IREDELL COUNTY HEALTH DEPARTMENT

IMPROVEMENT PERMIT / AUTHORIZATION TO CONSTRUCT / OPERATION PERMIT / EXISTING SYSTEM INSPECTION

PERMIT# 144364 PIN# 4738452972 DATE 8-31-07

RE: **Twin Creeks Estates**
Lot 57, 166 Twin Creek
HE-01000

INITIAL SITE SKETCH

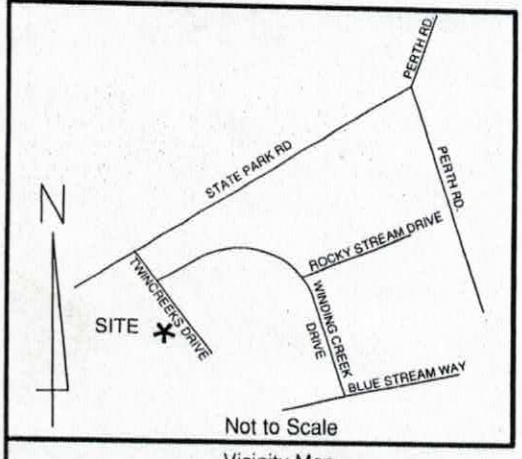
Comments/Conditions: ① Keep House Out of Ground & BACK FILL for the 10' Positive Drainage REQMTS. Septic Lines CAN NOT BE 5' OFF DRAINAGE, 15' OFF HOUSE AS DRAWN, EARTHWORK & MET WITH BUILDER

Comments/Conditions: ② CALL Prior to installation for Pump Sizing & System Specs if necessary ③ House & System completely FLAGGED OUT. House SLID BACK 20' From Original Staking. Drawn correctly on Permit. BUILDER OK'D

AS BUILT SKETCH SLIDING BACK 20'.

Plot Plan SURVEY
OF
Lot 57, Twin Creek Estates, Phase 2
Fallstown Twsp., Iredell County, N.C.

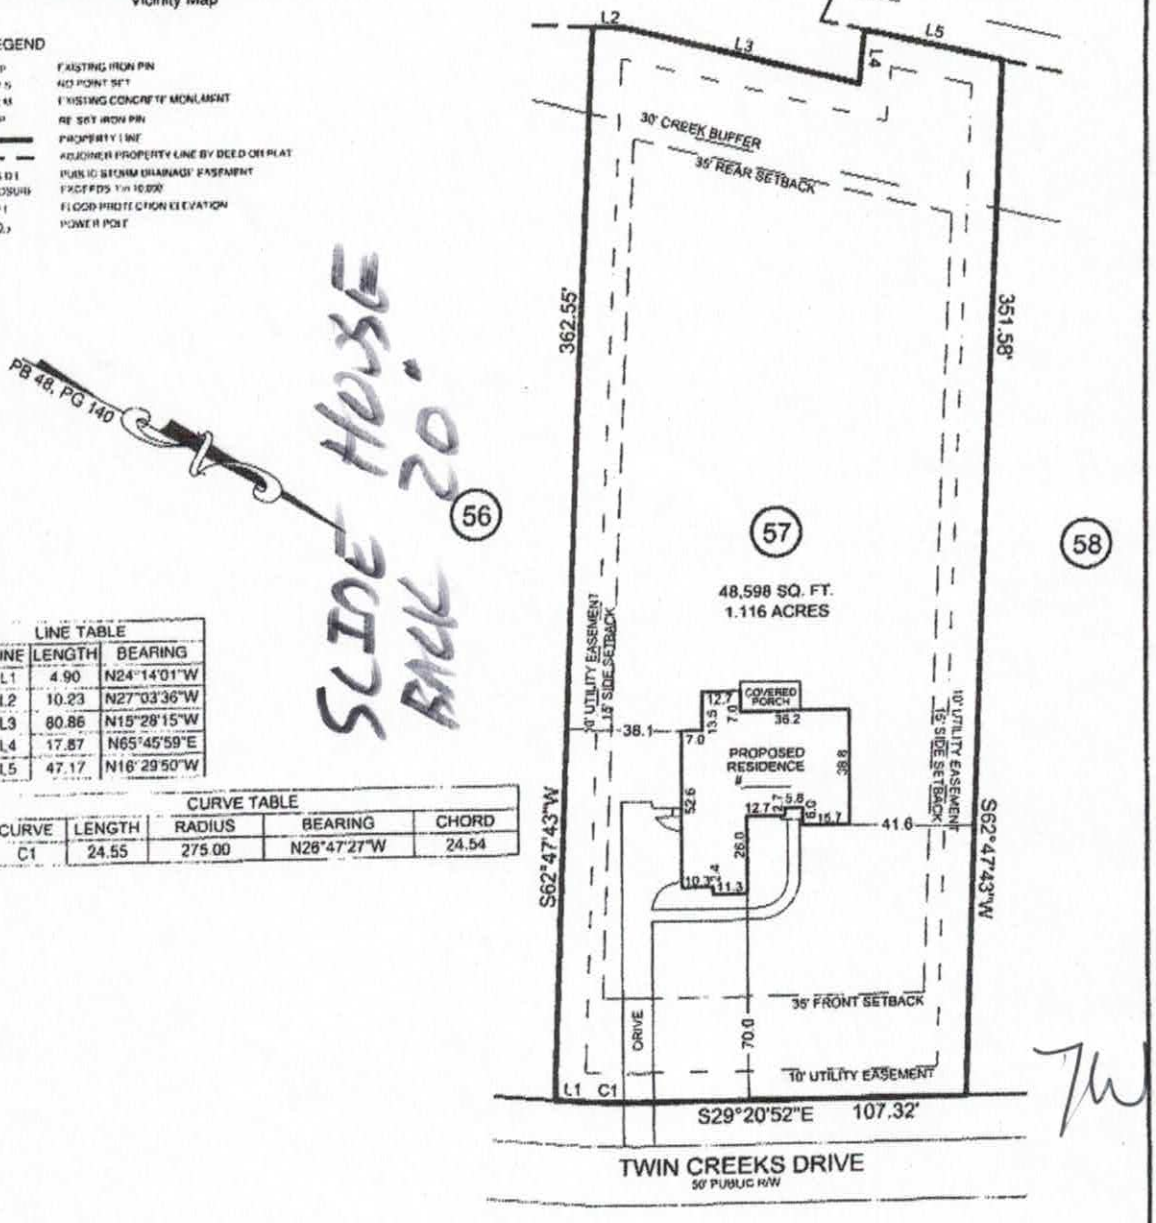
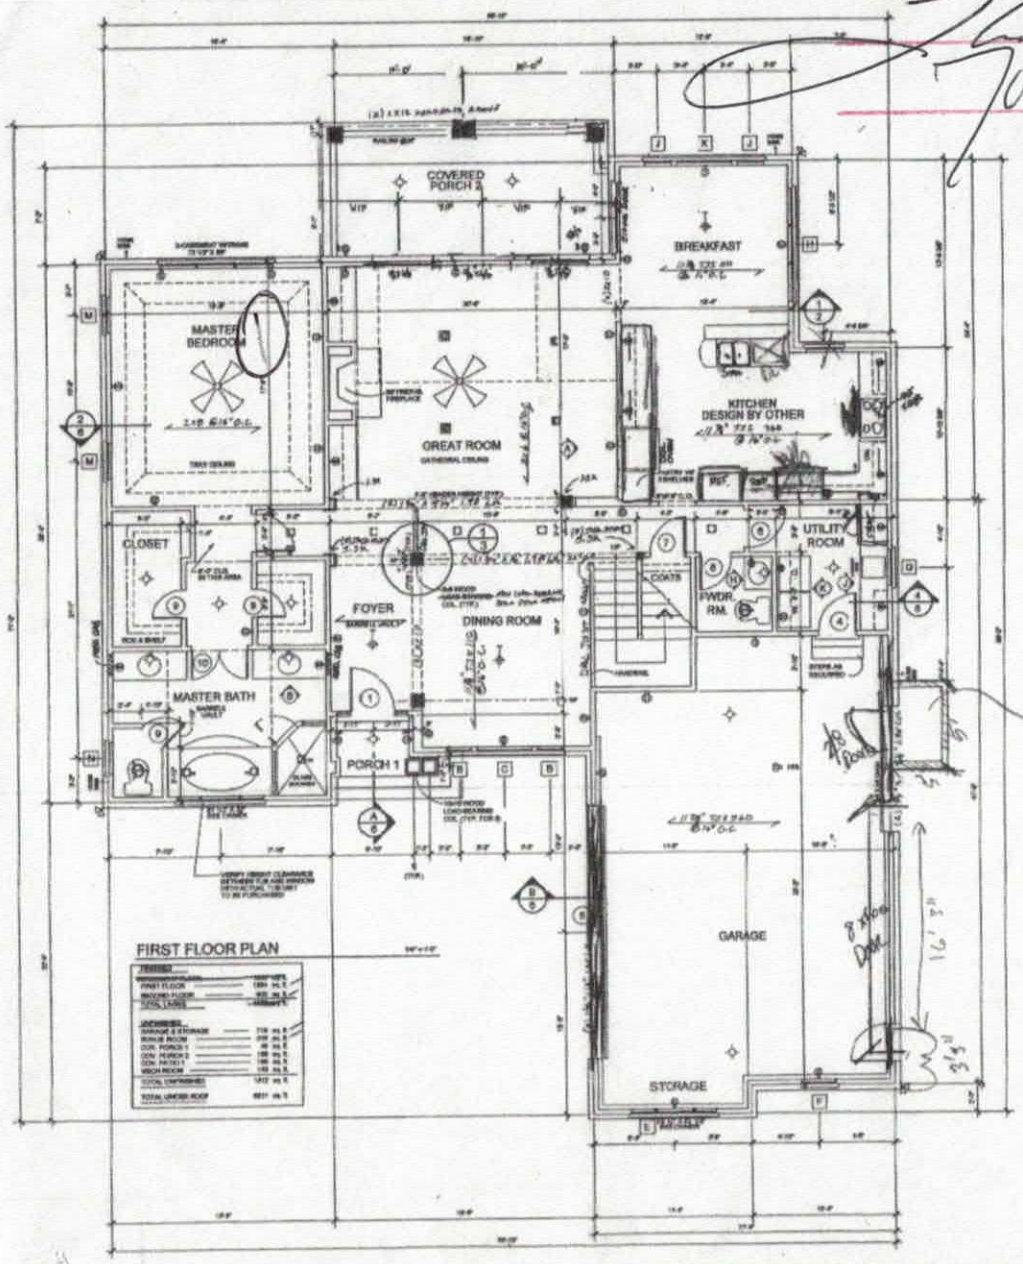
SLIDE House BACK 20'
